Access Compliance Report Public Rights-of-Way (Curb Ramps)

Main Street: BIMINI_DR Cross Street: DORSETSHIRE_LN Location: NW

ADA ID: RPRK211013130922 Ramp Type: Type 4 - Parallel Initial Pass/Fail: Fail Overall Compliance: No Severity Score: 30

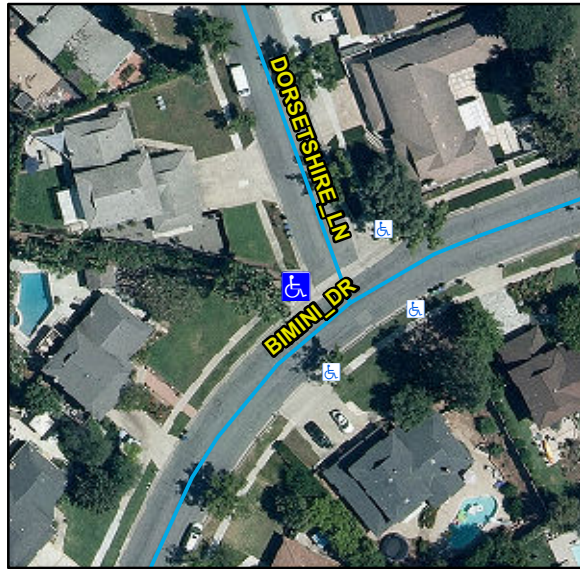
Compliance	Description	Data	Compliance	Description	Data
N/A	Ramp Length LT (in)	120	N/A	Ramp Length RT (in)	128
Yes	Ramp Width LT (in)	126	Yes	Ramp Width RT (in)	137
Yes	Ramp Run Slope LT (%)	4.6	Yes	Ramp Run Slope RT (%)	8.2
No	Ramp Cross Slope LT (%)	8.8	No	Ramp Cross Slope RT (%)	4.6
N/A	Landing Present	N/A	N/A	DWS Provided	N/A
N/A	Landing Length (in)	N/A	N/A	DWS Contrast	N/A
N/A	Landing Width (in)	N/A	N/A	DWS Length (in)	N/A
N/A	Landing Run Slope (%)	N/A	N/A	DWS Full Width	N/A
N/A	Landing Cross Slope (%)	N/A		DWS Offset Type	N/A
N/A	Landing Movement Obstructed?	N/A	N/A	DWS Offset Left (in)	N/A
	Landing Movement Type	N/A	N/A	DWS Offset Right (in)	N/A
N/A	Landing Shared	N/A			
N/A	Clear Space	Yes			
N/A	Clear Space To Crosswalk (in)	N/A			
N/A	Marked Crosswalk 1	No	N/A	Marked Crosswalk 2	No
	Crossing 1 Direction	S		Crossing 2 Direction	E
	Marked Crosswalk 1 Width (in)	N/A		Marked Crosswalk 2 Width (in)	N/A

Remove & Replace Curb Ramp With Two New Directional Ramps or Equivalent.
